DOMUSEA DEVELOPMENTS
PROPOSED RESIDENTIAL DEVELOPMENT
THE BOWERIES, BARNHAM ROAD,
EASTERGATE

REPEAT STAGE 1 - ROAD SAFETY
AUDIT

APRIL 2021

Report Title:	Designers Response
Date:	7 th April 2021
Document reference and revision:	Designers Response (Rev3)
Prepared by:	Domusea Developments
On behalf of:	Domusea Developments

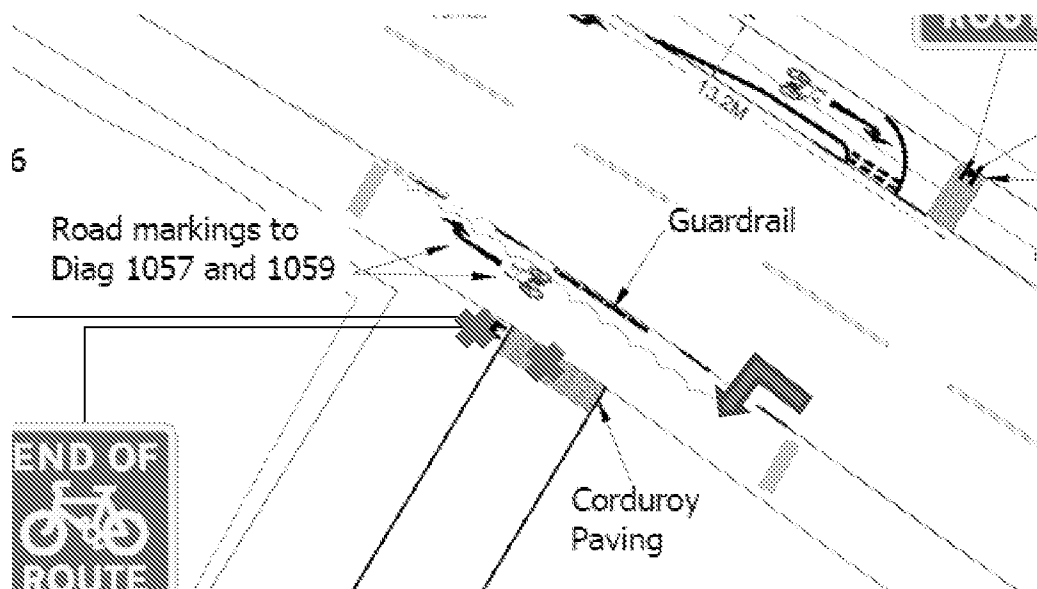
Location: Barnham Road, south side, adjacent to proposed shared use pedestrian/cycle facility.

Summary: Cycle route continuity unclear.

Whilst a dropped kerb has been provided for westbound cyclists on Barnham Road to leave the carriageway and join the shared use pedestrian/cycle facility on the northern side of the development site, no cycle markings have been provided to ensure that westbound cyclists are able to identify this facility.

Furthermore, whilst 'end of route' signing is provided at the northern end of the shared use pedestrian/cycle facility, it is considered that in practice, cyclists will not stop and dismount at this point, but continue across the footway and join the carriageway. Similarly, westbound cyclists are highly unlikely to dismount immediately when they leave the carriageway and enter the footway. It will be important that pedestrians travelling east-west on the southern footway are aware that they might be sharing the facility with faster moving cyclists.

- i. A short section of the footway on the southern side of Barnham Road, adjacent to the north-south shared use pedestrian/cycle facility, should be designated a shared use facility.

- ii. Cycle logos and direction arrows are provided adjacent to the dropped kerb to the east of the 'greenway'.
- iii. Corduroy paving should be provided to the west of the western dropped kerb provided for cycles to rejoin the carriageway, and to the east of the eastern dropped kerb provided for westbound cyclists to leave the carriageway, to ensure vision impaired pedestrians are aware when they step onto/into the cycle facility.
- iv. Appropriate cycle signing should be provided.
- v. Remove the corduroy paving and signing at the northern end of the proposed shared use pedestrian/cycle facility.

RSA Problem	RSA Recommendation	Design Organisation Response	Overseeing Organisation Response	Agreed RSA action
3.2 Problem Location: Barnham Road, south side, adjacent to proposed shared use pedestrian/cycle facility.	i. A short section of the footway on the southern side of Barnham Road, adjacent to the north-south shared use pedestrian/cycle facility, should be designated a shared use facility. ii. Cycle logos and direction arrows are provided adjacent to the dropped kerb to the east of the 'greenway'.	Agree with auditor, it can be dealt with as part of the detailed design and S278 process.

iii. Corduroy paving should be provided to the west of the western dropped kerb provided for cycles to rejoin the carriageway, and to the east of the eastern dropped kerb provided for westbound cyclists to leave the carriageway, to ensure vision impaired pedestrians are aware when they step onto/into the cycle facility. iv. Appropriate cycle signing should be provided. v. Remove the corduroy paving and signing at the northern end of the proposed shared use pedestrian/cycle facility.			
--	--	--	--	--

drawing number **MBSK210326/02** rev. **-**

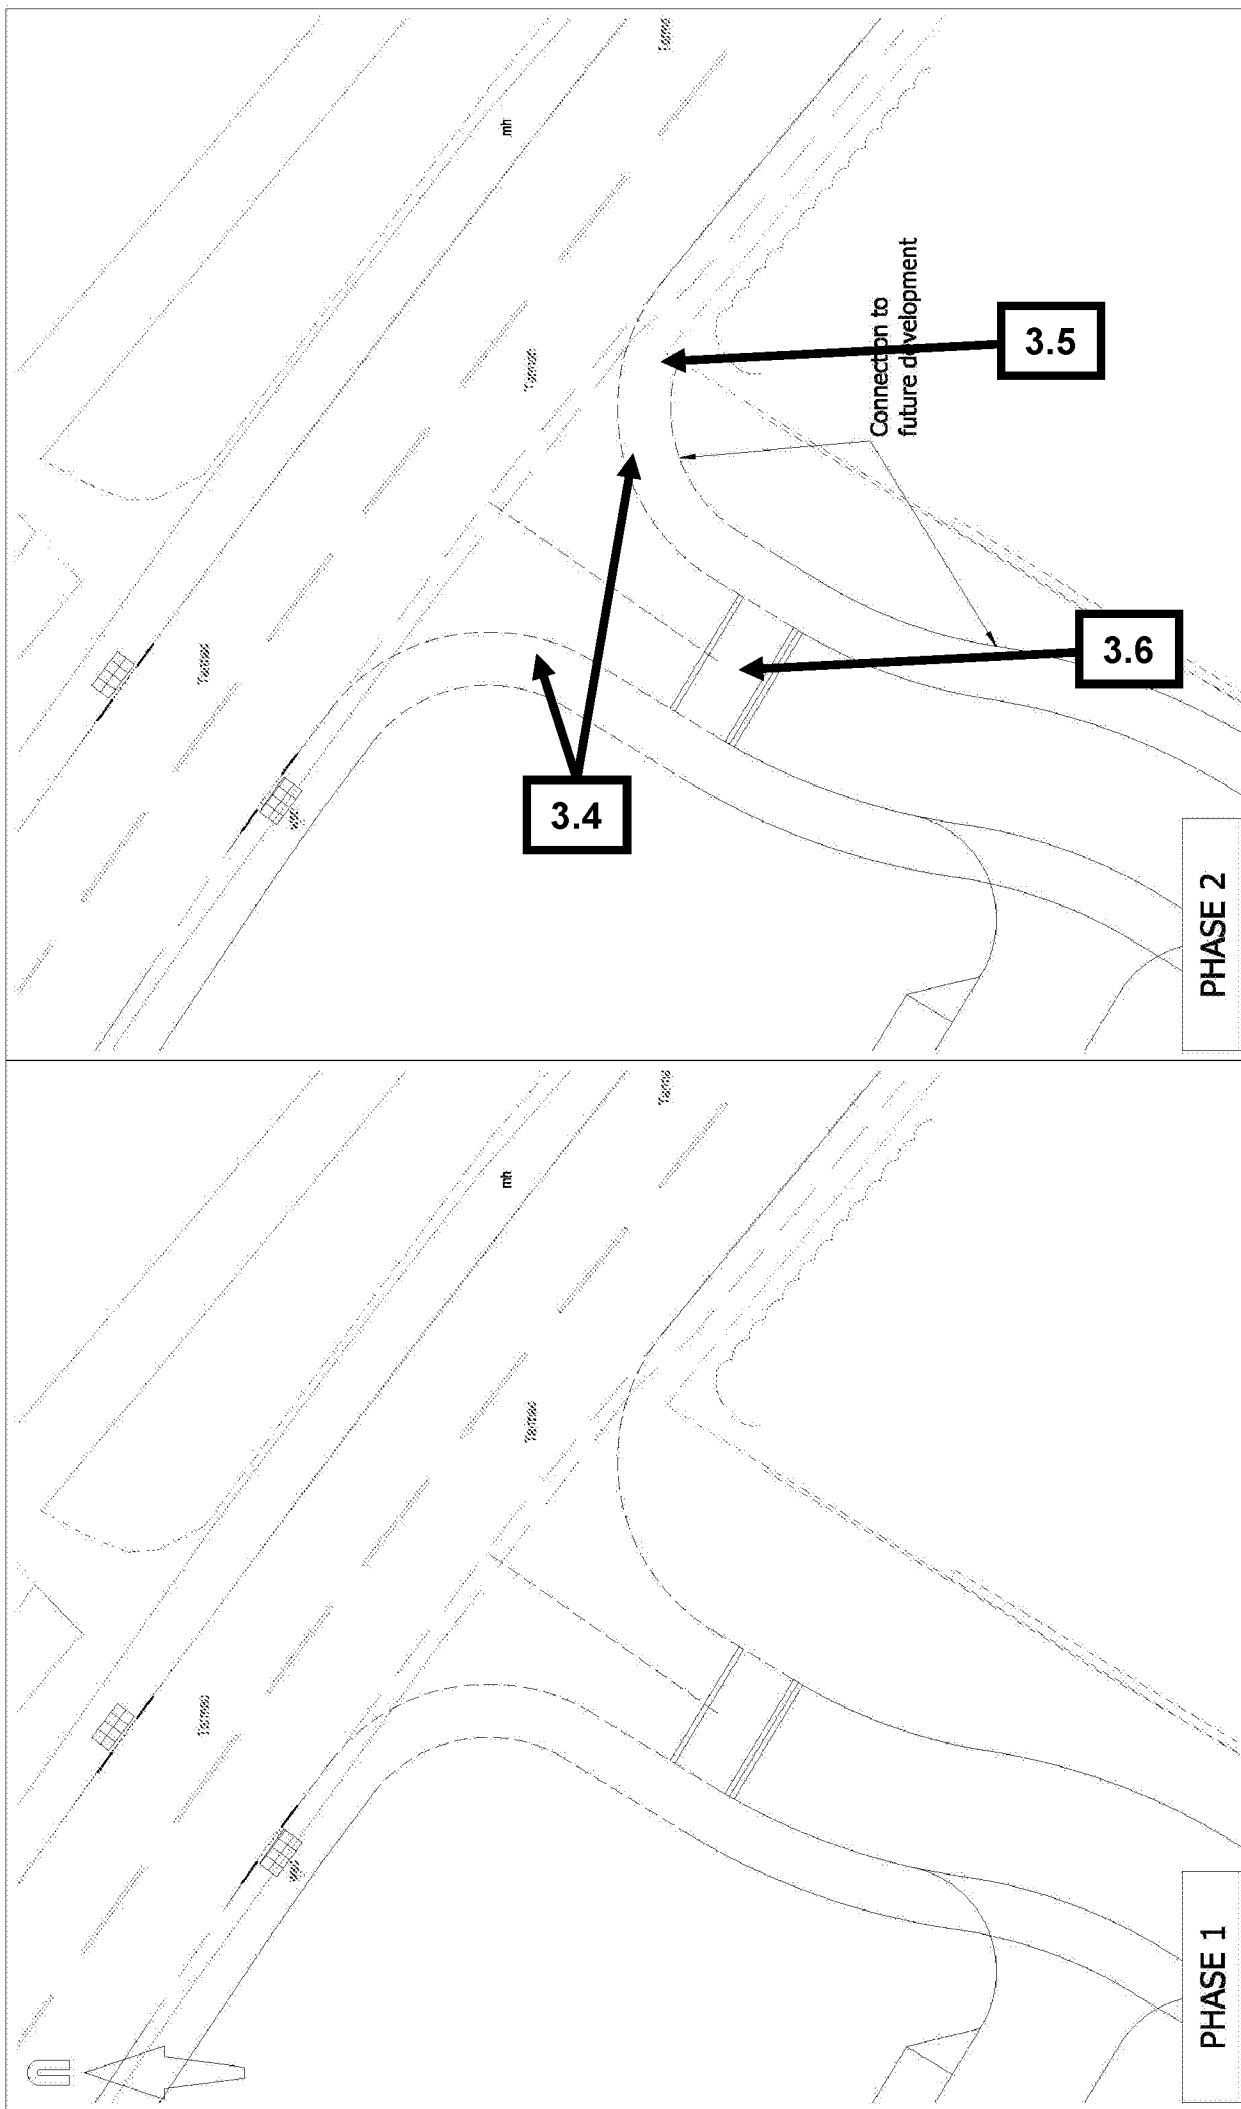
Location: Site access (please refer to reference point 3.1 in **Appendix B**).

Summary: Pedestrian/cycle inter-visibility splays.

It will be important to ensure that appropriate inter-visibility splays are provided to reduce the risk of pedestrians and/or cyclists emerging from the shared pedestrian/cycle facility into the path of pedestrians travelling east-west on the southern footway.

It is recommended that appropriate inter-visibility splays are provided at the northern end of the shared pedestrian/cycle facility.

Location: Barnham Road, north side, adjacent to proposed shared use pedestrian/cycle facility (please refer to reference point 3.3 in **Appendix B**).

Summary: Excessive road markings may result in unclear priority for road users.

A short 13m shared use facility has been provided on the northern side of Barnham Road to enable eastbound cyclists to leave the carriageway and stop to wait for a break in the general traffic flow before crossing Barnham Road to join the 'greenway' adjacent to the development site.

However, there is concern that the cycle delineation markings, may indicate to cyclists that this section is for pedal cycles only. This could result in cyclists entering this section, potentially at speed, resulting in conflict and/or pedestrian/cycle collisions.

It is recommended that the cycle symbol and direction arrow are retained, but the delineation markings are removed.

Location: Site access, 'Phase 2' only (please refer to reference points 3.4 in **Appendix B**).

Summary: No pedestrian crossing point on desire line.

It will be important to provide dropped kerbs and tactile paving on all pedestrian desire lines to ensure continuity of the pedestrian route. Failure to do so may result in pedestrians, especially the vision and mobility impaired, tripping on kerbs, or unable to cross the carriageway.

It is recommended that dropped kerbs and tactile paving are provided in accordance with relevant design standards on the pedestrian desire line.

Location: Site access, 'Phase 2' only (please refer to reference point 3.5 in **Appendix B**).

Summary: Pedestrian route continuity and pedestrian facilities.

A footway has been provided on the eastern side of the site access, however there is no footway currently on the southern side of Barnham Road near the development site. An existing footway is provided on the southern side of the Barnham Road circa 250m from

the site access. This could lead to pedestrians walking in the carriageway, with subsequent risk of being struck by a moving vehicle.

- i. A footway is provided on the southern side of Barnham Road linking the proposed footway on the eastern side of the site access and the existing footway located 250m to the east. If it is not possible to link the proposed footway with the existing footway, then a pedestrian crossing point should be provided at the termination point of the footway or
- ii. Remove the footway on the eastern side of the site access.

Location: Site access (please refer to reference point 3.6 in **Appendix B**).

Summary: Transition ramps/ramp warning triangles.

There appears to be a raised table provided on the site access road. If this is a raised table, then it will be important that approaching drivers/riders are able to identify the transition ramps on approach so that they can adjust their speed/riding position as appropriate to reduce the risk of losing control.

It will also be important to ensure that the gradient of the transition ramps is appropriate for anticipated vehicle speeds. Ramps that are too short/steep may increase the risk of vehicles/powered two wheelers losing control and/or damaging the vehicles.

It is recommended that white warning triangles (Diag 1062) are provided on the speed reducing ramps. Ensure appropriate gradients are provided on both of the transition ramps.

RSA Problem	RSA Recommendation	Design Organisation Response	Overseeing Organisation Response	Agreed RSA action
3.1 Problem Location: Site Access	It is recommended that appropriate inter-visibility splays are provided at the northern end of the shared pedestrian/cycle facility.	Agree with auditor, it can be dealt with as part of the detailed design and S278 process.

RSA Problem	RSA Recommendation	Design Organisation Response	Overseeing Organisation Response	Agreed RSA action
3.3 Problem Location: Barnham Road, north side, adjacent to proposed shared use pedestrian/cycle facility	It is recommended that the cycle symbol and direction arrow are retained, but the delineation markings are removed.	Agree with auditor, it can be dealt with as part of the detailed design and S278 process

RSA Problem	RSA Recommendation	Design Organisation Response	Overseeing Organisation Response	Agreed RSA action
3.4 Problem Location: Site access, 'Phase 2' only	It is recommended that dropped kerbs and tactile paving are provided in accordance with relevant design standards on the pedestrian desire line.	Agree with auditor, it can be dealt with as part of the detailed design and S278 process.

RSA Problem	RSA Recommendation	Design Organisation Response	Overseeing Organisation Response	Agreed RSA action
3.5 Problem Location: Site access, east side	It is recommended that either: i. A footway is provided on the southern side of Barnham Road linking the proposed footway on the eastern side of the site access and the existing footway located 250m to the east. If it is not possible to link the proposed footway with the existing footway, then a pedestrian crossing point should be provided at the termination point of the footway. or ii. Remove the footway on the eastern side of the site access.	It is proposed that the footway is removed on the eastern side of the site access.

RSA Problem	RSA Recommendation	Design Organisation Response	Overseeing Organisation Response	Agreed RSA action
3.6 Problem Location: Site access	It is recommended that white warning triangles (Diag 1062) are provided on the speed reducing ramps. Ensure appropriate gradients are provided on both of the transition ramps.	Agree with auditor, it can be dealt with as part of the detailed design and S278 process.

drawing number MBSK191001-01

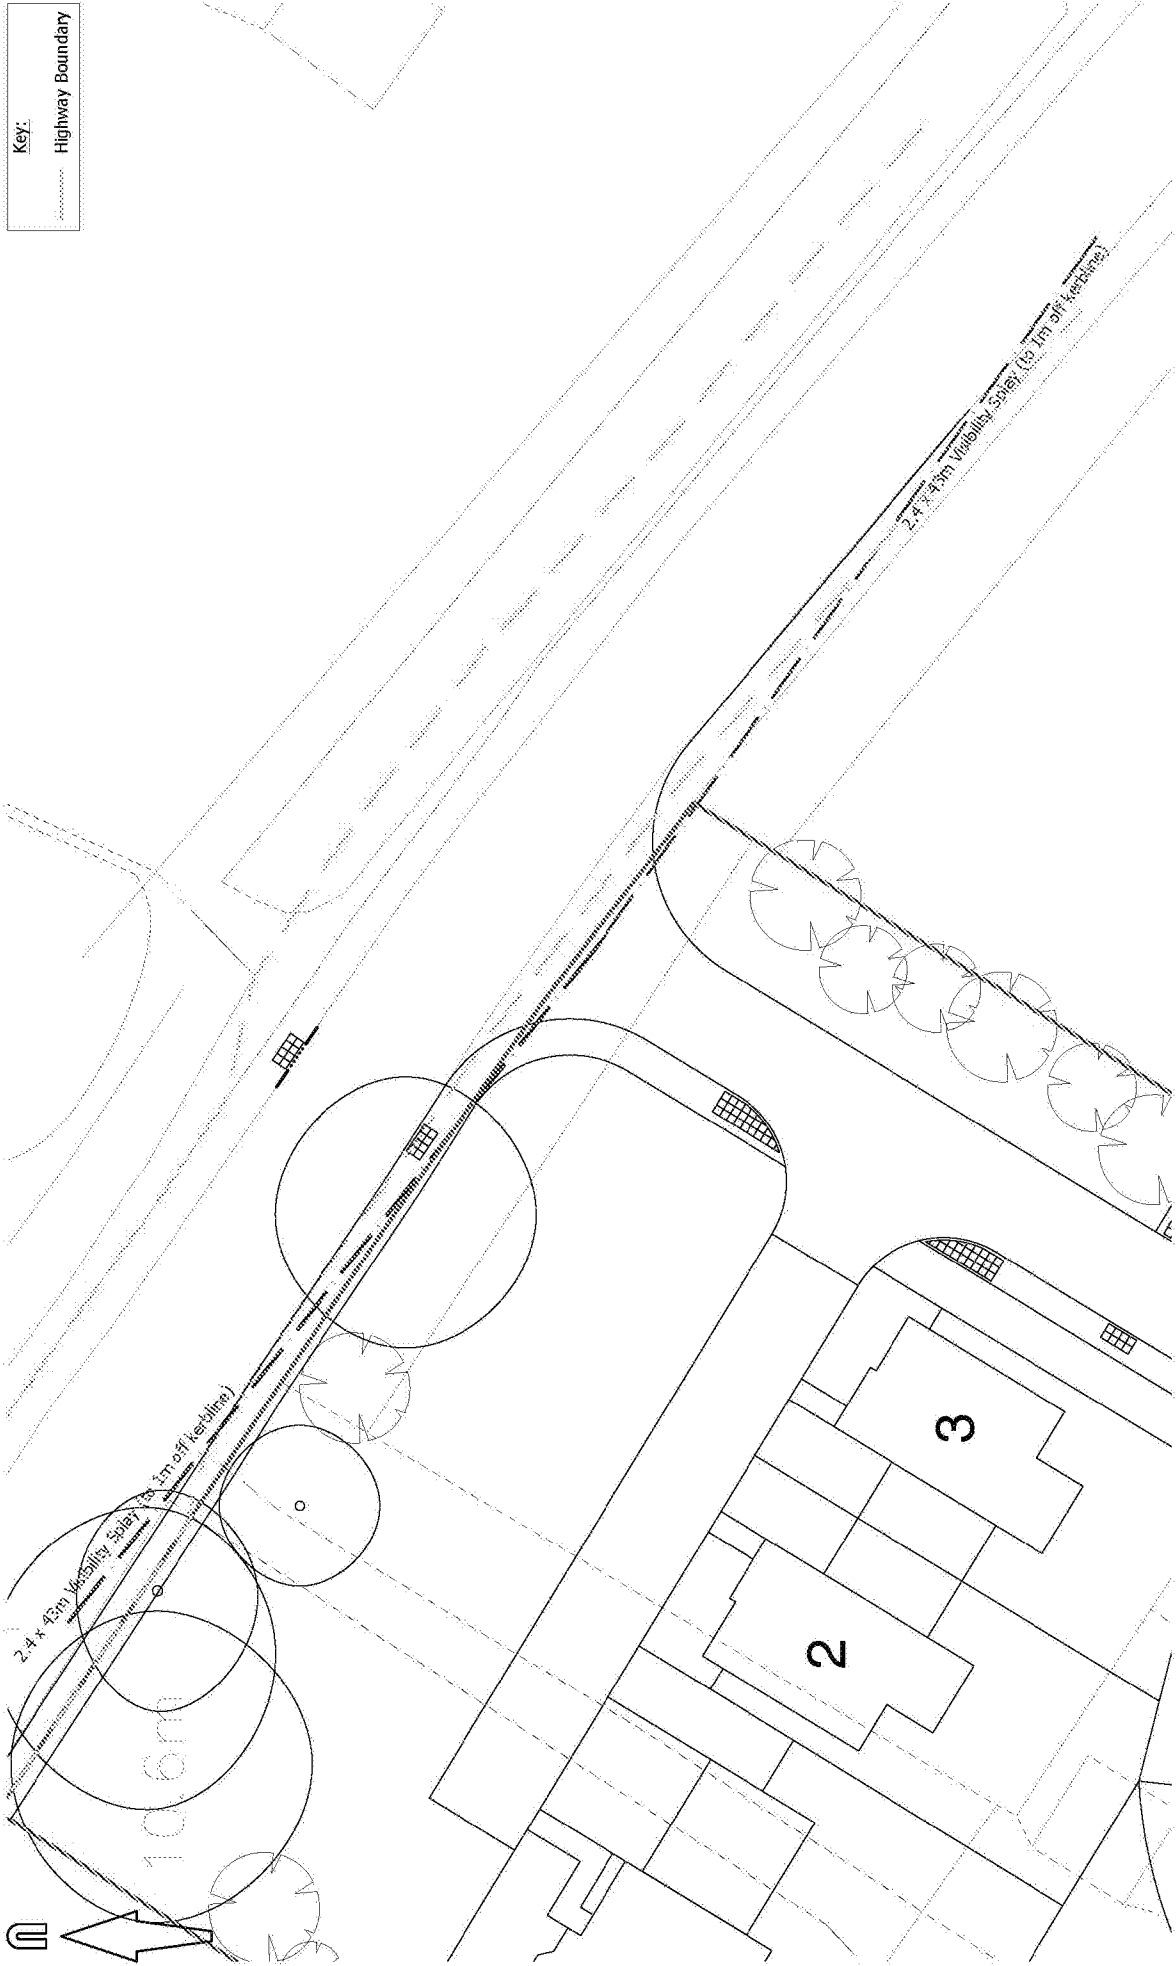
Location: Site Access

Summary: Obstruction to visibility splays

Junction visibility splays have been formally identified on the drawings provided for Audit. It will be important that any vegetation within these splays is trimmed/maintained to ensure that the visibility splays remain unobstructed.

- i. Any vegetation within the splays should be trimmed/maintained.
- ii. Vegetation within the splays should not extend beyond a vertical height of 0.6m.
